STAFF RECOMMENDATION

NCPC File No. 6546

**FORT LESLEY J. McNAIR,
NATIONAL DEFENSE UNIVERSITY EXPANSION, PHASE II
4th and P Streets, SW
Washington, DC**

November 24, 2004

NDU EXPANSION BUILDING PLAN – FIRST FLOOR

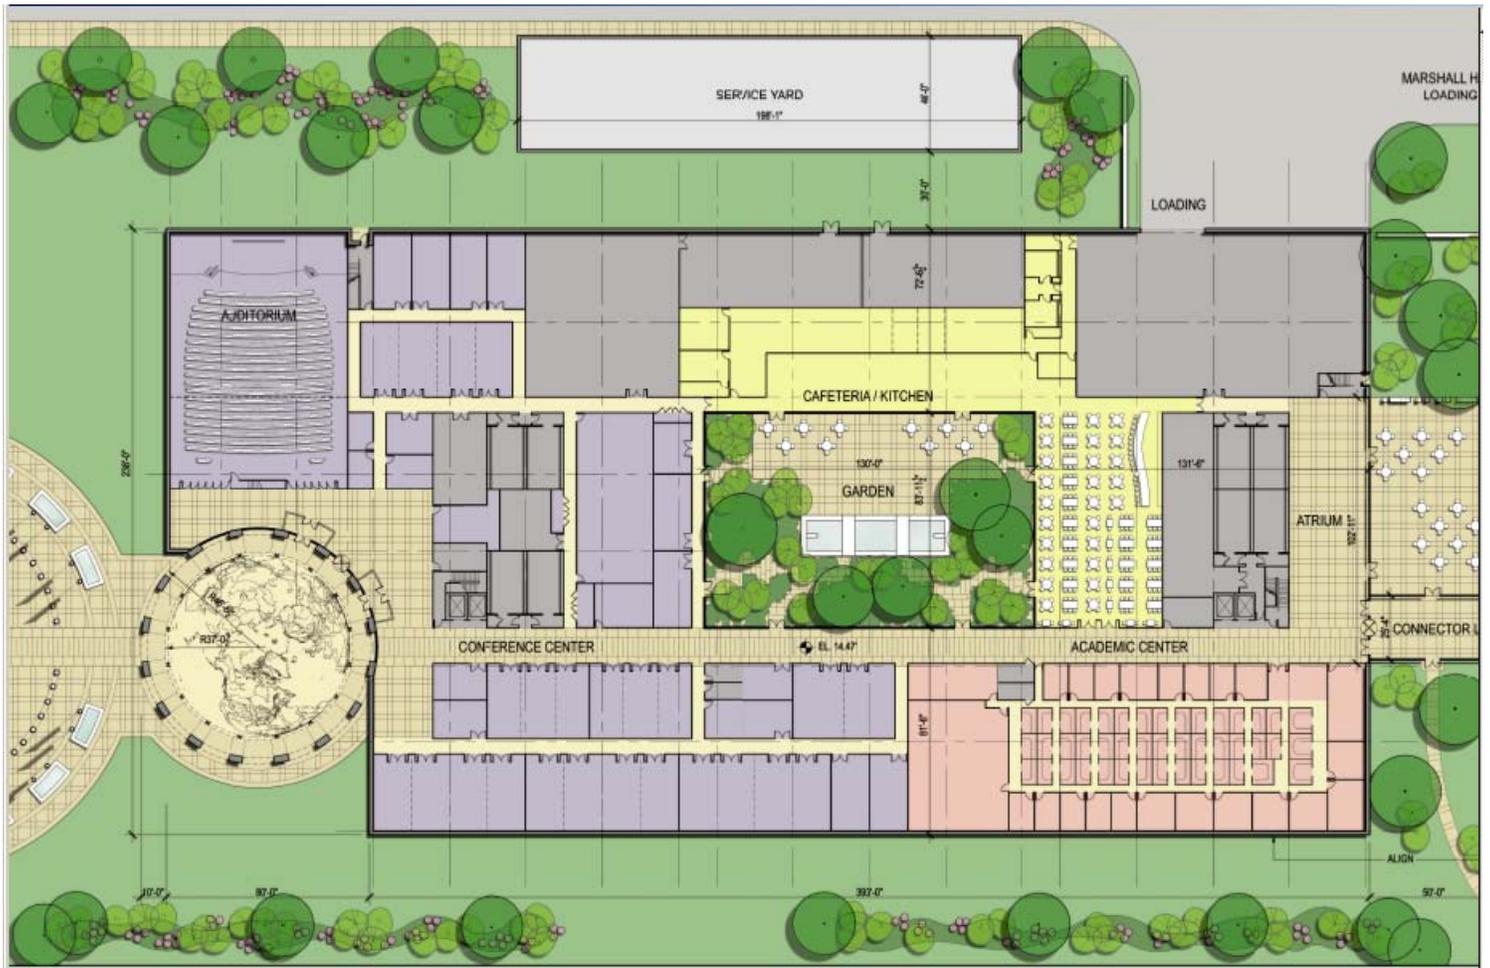
First is the physical link provided by the project with Marshall Hall. The only connection established by the current design is at the first floor level. Staff believes providing only a one level connection is at odds with the Commission's earlier approval of the Marshall Hall and NDU goals of a visually orienting fully open circulation corridor that transitions throughout the NDU complex. Forcing visitors, staff, and students to move to a lower level from the new building to reach Marshall Hall is not in keeping with the aim of open wayfinding for the University and certainly impedes visual references to the other portions of the adjacent Marshall Hall. Additionally having only a ground level connection creates long and unnecessary travel times between buildings and floor levels of each building.

Finally, staff finds that although the NDU building addition entrance and its architectural feature of the “drum”, an entry enclosure portal, is reasonably defined and appropriately located; it lacks impact except by its contrasting shape and color. Staff believes additional emphasis could be achieved by elevating the height of the entrance element and perhaps integrating it with the peaked roofline of the central corridor as the corridor extends north through the length of the building.

- Modify the connection between the NDU Expansion and Marshall Hall so that it connects to all floor levels within Marshall Hall or becomes a full-height vaulted space.

- Maintain the existing free standing brick wall along 5th Avenue in the project site design.
- Develop additional emphasis to the NDU Expansion entry “drum” by elevating the height of the entrance element and integrating it with the recommended peaked roofline of the central corridor,

NDU EXPANSION BUILDING ELEVATION

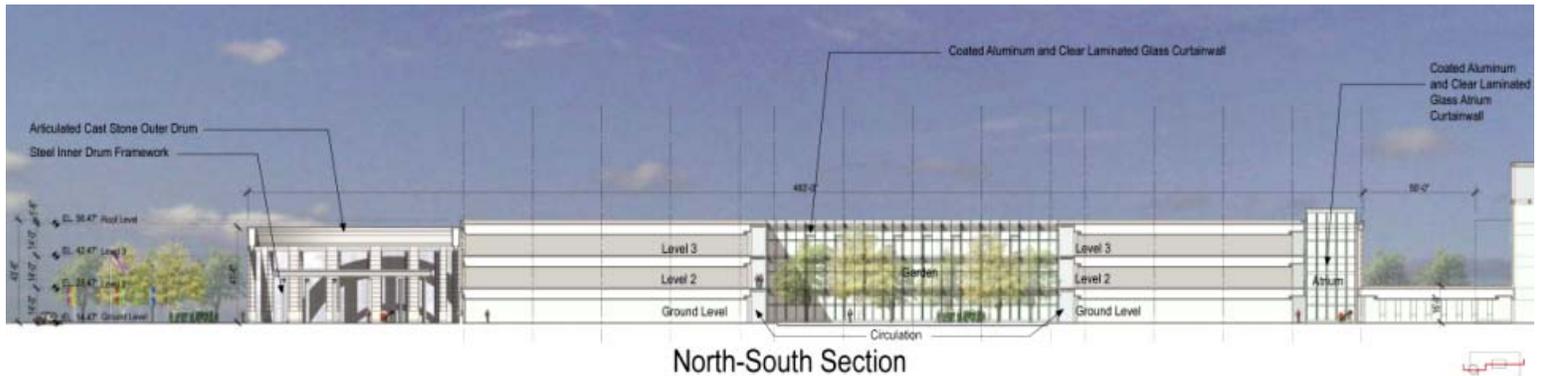
corridor. Marshall Hall maintains an important orienting feature of the main cross corridors and the through-views within the corridor toward the north/south axis and the river shore. That orienting theme is continued by the NDU Expansion but fails to express its importance externally at the roof line. Staff believes it is essential to provide an elevated skylight or roof peak at the corridor, similar to that found on the existing Marshall Hall, in order to maintain the consistency and expressed significance of the central corridor throughout the NDU. Staff also believes more sharply defined building wall setbacks and offsets would provide, at the east and west elevations, a better correlation to window areas and the floor plan layout. Additionally the effort would give stronger shadow definition to the elevations as a whole.

- Provide a continuous skylight or vaulted roof above the NDU Expansion central corridor, similar to that found on the existing Marshall Hall, to maintain the consistency and expressed importance of the central corridor throughout the NDU complex.

- Establish clearly-defined building wall setbacks /offsets along the east and west elevations to improve the relationship between window areas and the floor plan layout, and to create stronger shadow definition within the elevations.
